Smaller, Systematic Physical Solutions to Enhance the District

South Grand Commercial District Parking Study

Sheet 11.1
Date: November 25, 2002

Solution #13 Curb Bump Outs & #14 Marked Pedestrian Crossings

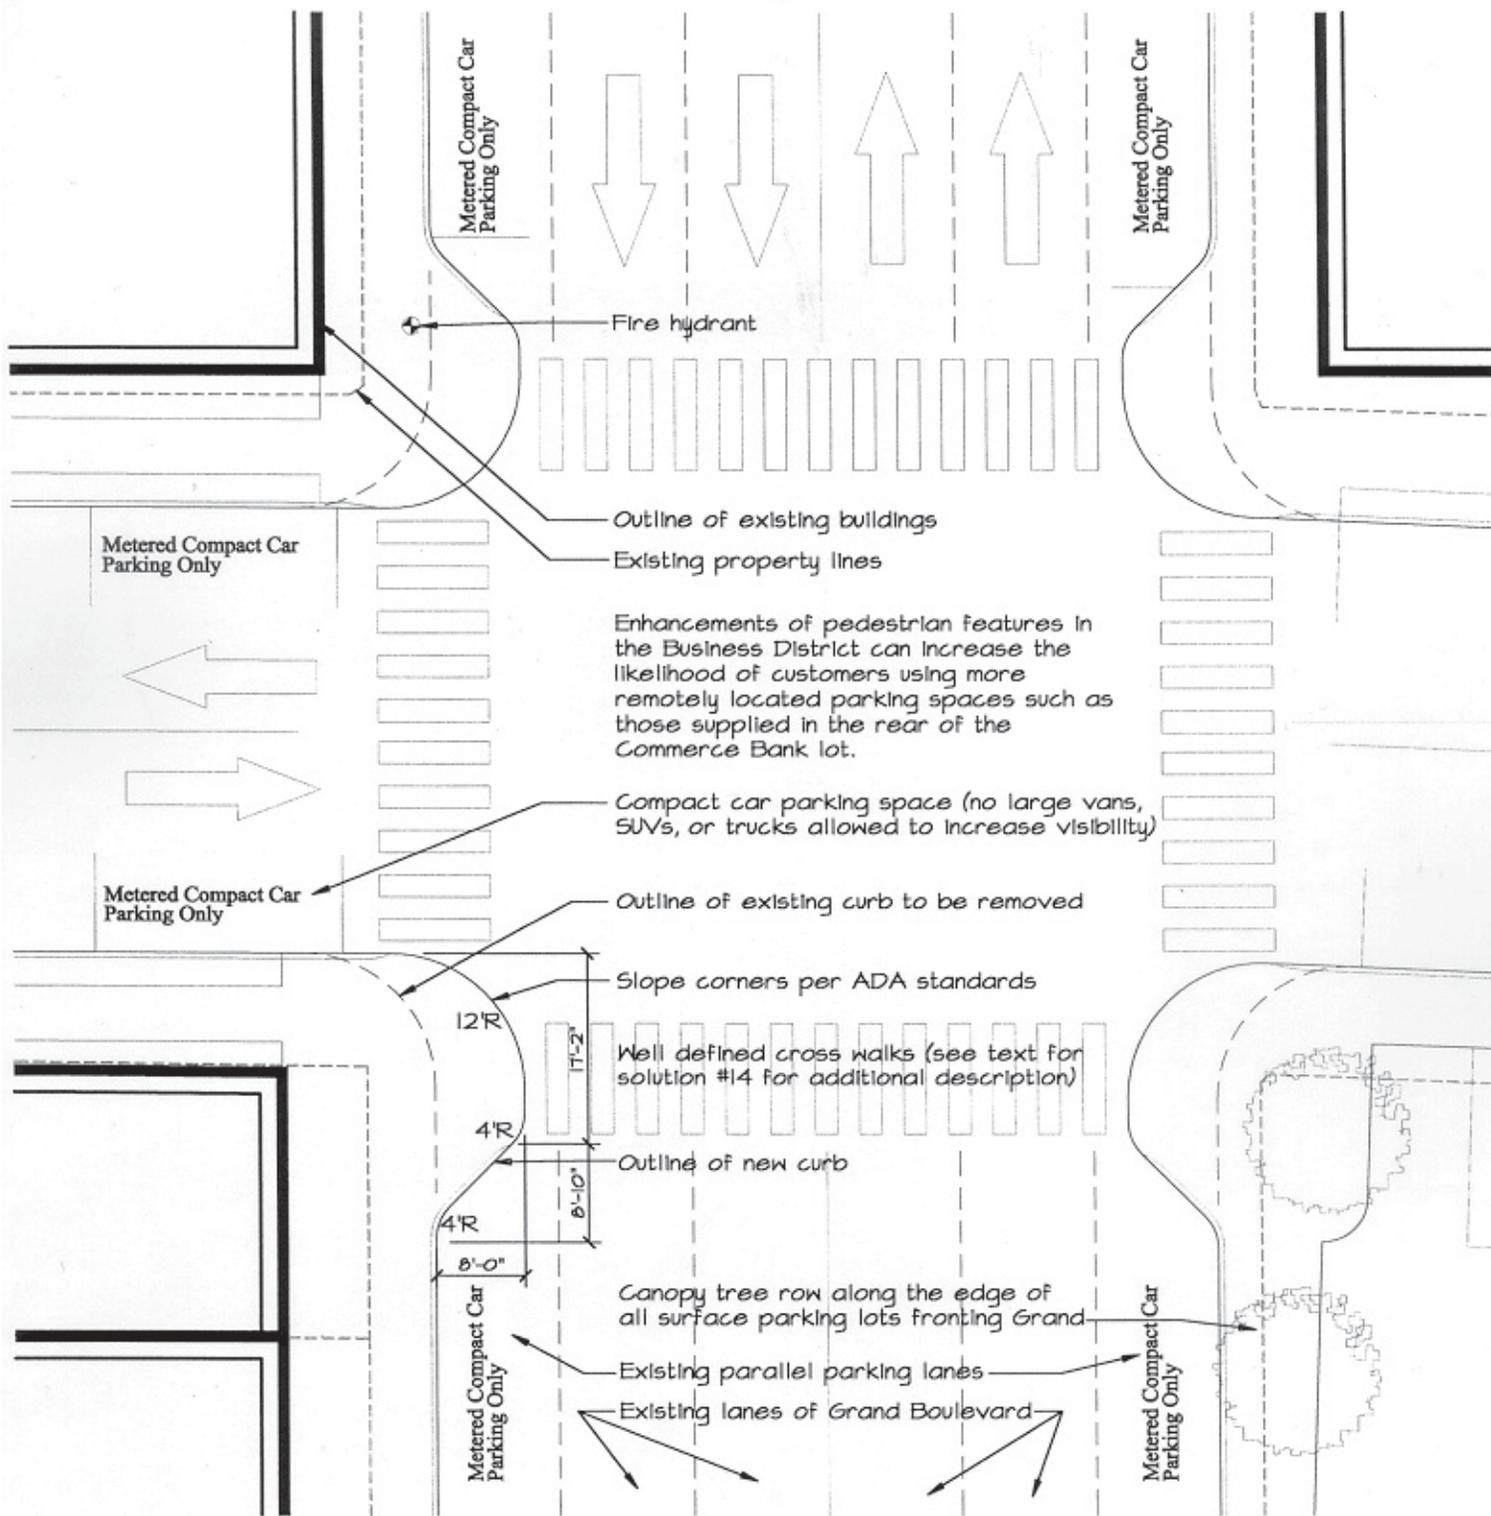
13. Install curb bump outs at each cross street and Grand Avenue (standard drawing will be provided later). This curb should project out into the parking lane along Grand Avenue. The side streets are narrow enough that they may not need this enhancement. This detail will increase pedestrian safety for crossing Grand, and also increase curb length along side streets, which possibly will increase parking on the side streets. Curb bump outs have been installed in downtown Clayton in several locations.

The District has previously considered curb bump-outs and similar pedestrian-friendly solutions. The District has decided not to request expansion of T-21 funds allocated to South Grand north of Arsenal to extend further south. Thus, the South Grand CID intends to make its own application for Future T-21 enhancement grants that could cover a portion of the costs of a comprehensive streetscape plan. (Steering Committee member comment)

14. Clearly mark all pedestrian crossings, including the side street crossings within the Business District. This will enhance pedestrian safety, and could strengthen District character if designed more uniquely than the standard striping patterns. Some municipalities have used pavers (U City Loop), while others have installed colored concrete (Richmond Heights). The pavement changes are expensive solutions. A more unique approach would be to conduct an artist design competition to create street cross walk stencils that could artistically delineate cross walks in a dramatic design or pattern. The paint will need to be the durable type typically used on streets, but the shapes or patterns do not have to be solely stripes or blocks of paint. It could actually encourage pedestrian activity throughout the district.

The parking solution drawings show the addition of this detail in the plan. A larger detail drawing of this concept is also provided. The additional curb length will sometimes create a new parking space on side streets.

The solution drawings show the addition of marked pedestrian cross walks at Juniata and Connecticut, where none currently exist. See more detailed description of this at solution #21.

Solution #15 Street Lighting & #16 Limb Up Street Trees

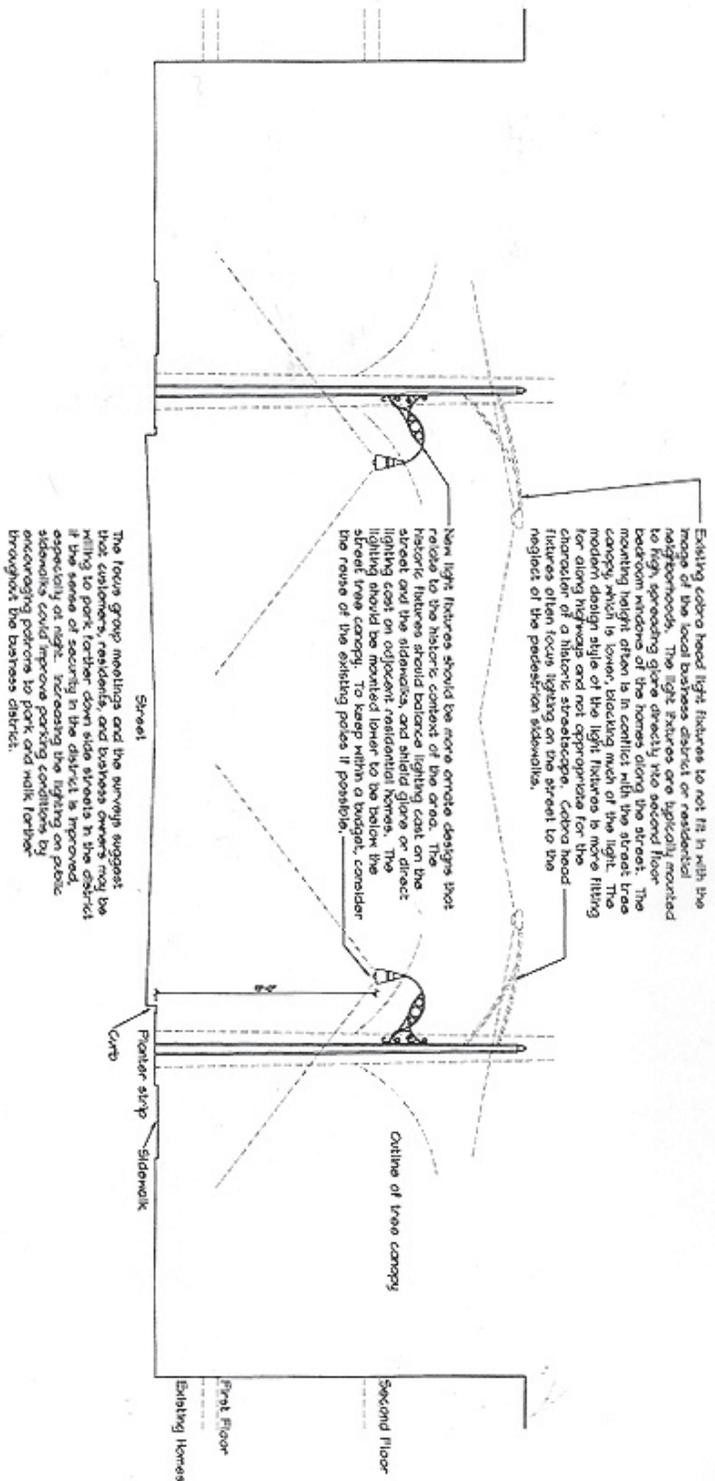
15. Install historic street lighting throughout the district. Specific research should identify a street light fixture that satisfies required lighting level for Grand without sacrificing aesthetic quality. The existing historic fixtures have poor lighting output levels, especially on the streets. The larger cobra head light fixtures are more appropriate along highways and tend to illuminate second floor residential bedrooms. High quality historic lighting will reinforce the character of the local district while also increasing the feeling of security of residents and customers. An increased feeling of security could increase the distance that employees and customers are willing to park down residential side streets. Avoid the silly looking situation where both historic lighting and modern cobra head fixtures are installed like the Kingshighway Bridge.

Yes, Historic Street Lighting. Also, improve lighting on side streets (resident comments).

Existing column head light fixtures to not fit in with the image of the local business district or residential neighborhoods. The light fixtures are typically mounted to high, spreading globe directly into second floor bedroom windows of the homes along the street. The mounting height often is in conflict with the street tree canopy, which is lower, blocking much of the light. The modern design style of the light fixtures is more fitting for dining neighborhoods and not appropriate for the historic character of the business district. The light fixtures often cause lighting on the street to be the neglect of the pedestrian sidewalks.

New light fixtures should be more ornate designs that relate to the historic context of the area. The historic fixtures should balance lighting cast on the street and the sidewalks, and shield glare or direct lighting cast on adjacent residential homes. The lighting poles should be made of materials that are more fitting for the historic character. If possible, consider the reuse of the existing poles if possible.
